Information Bulletin

Issue raised: **Toyota Corolla AE95 Wagon Front Bar**

Date identified: **10/05/04**

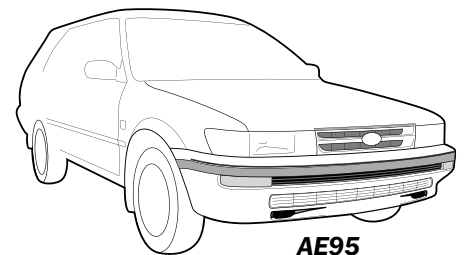
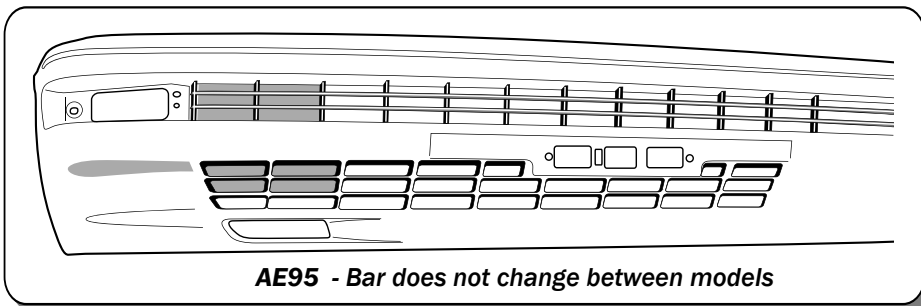
Above is the approximate measurements of the bracket mounting area of the early model bar **TCG-04010**.

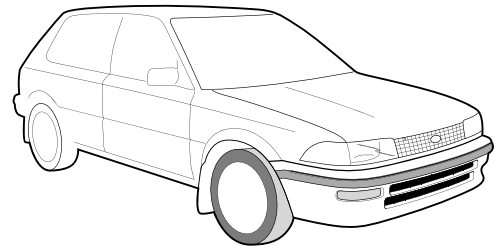
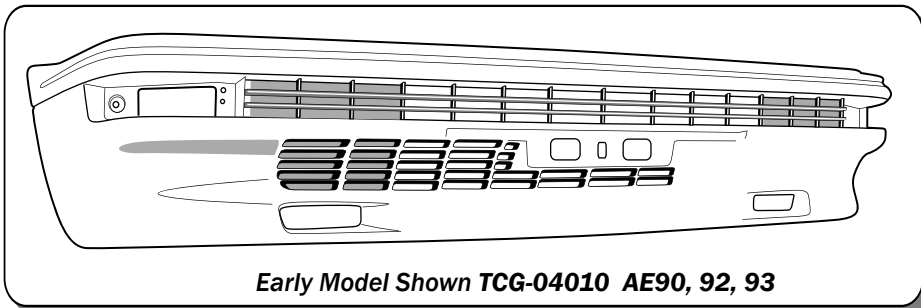
Above is the approximate measurements of the bracket mounting area of the **Genuine AE95** bar.
